802.1CB-2017

Maintenance item #378

March 10 2025

Maintenance item #378

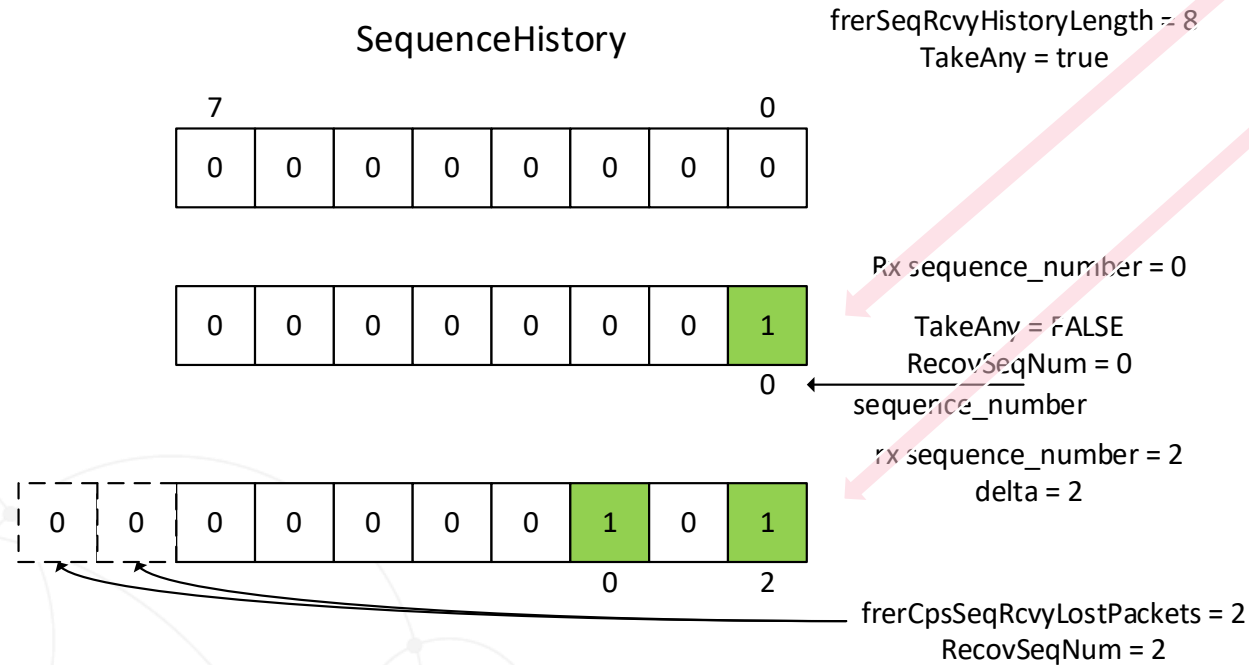
- Packets not yet seen after a sequence history reset are erroneously counted as lost
 - Description
 - The VectorRecoveryAlgorithm calls ShiftSequenceHistory routine when it processes a packet with a sequence number that is in the future (but still falls within the SequenceHistory). The ShiftSequenceHistory routine erroneously increments the counter frerCpsSeqRcvyLostPackets as it can't differentiate the packets that are actually lost from the packets that are not yet seen. This is due to the fact that SequenceHistory is initialized to all zeros by the SequenceRecoveryReset routine that initializes the SequenceRecovery instance.

Problem Illustration

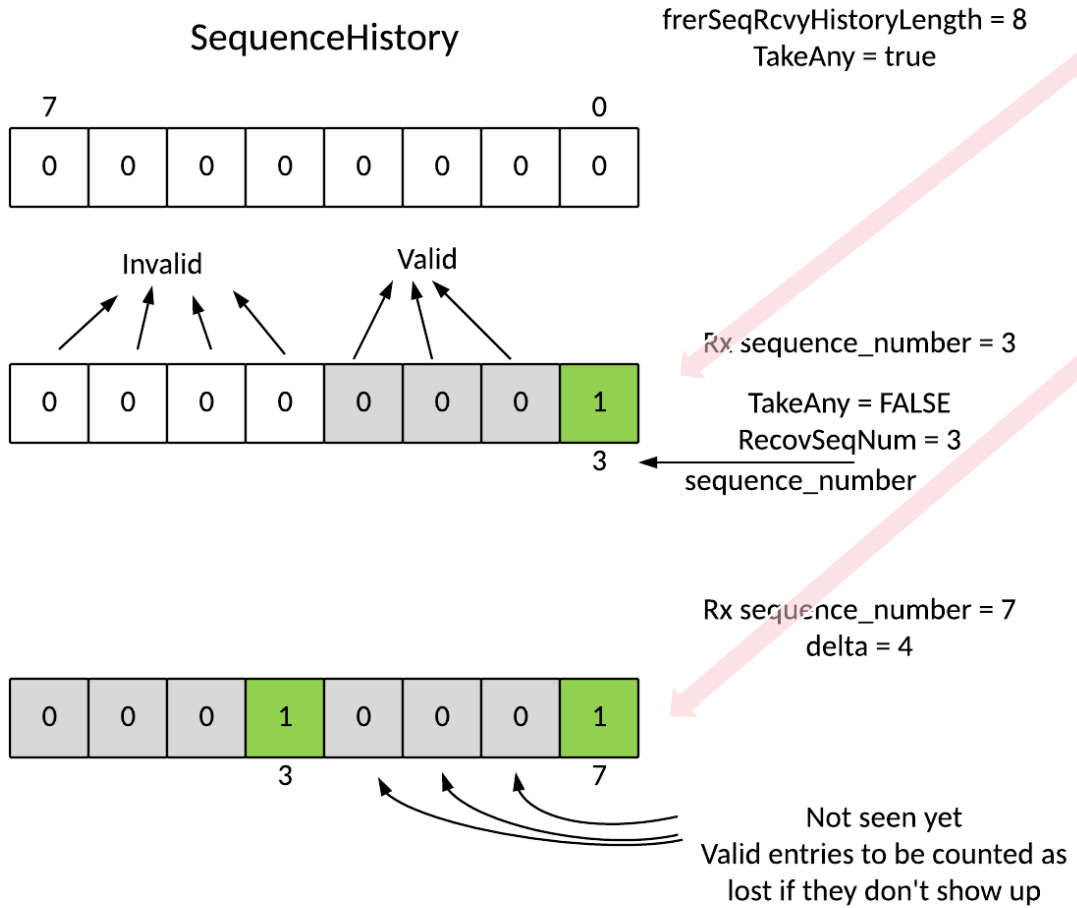
- First frame received with sequence_number 0 in this example
 - Bit 0 of SequenceHistory is set, bit 0 represents sequence_number 0
- Next frame that arrives with sequence_number 2
 - SequenceHistory array gets shifted as shown
- frerCpsSeqRcvyLostPackets is incremented erroneously twice for zero bits that got shifted out though these are not missing
- Potentially up to SequenceHistoryLength – 1 packets could be miscounted as lost
 - How many depends on the arrival order of sequence numbers.
- Algorithm needs to mark the array entries one through seven as invalid when first frame with sequence_number 0 is received
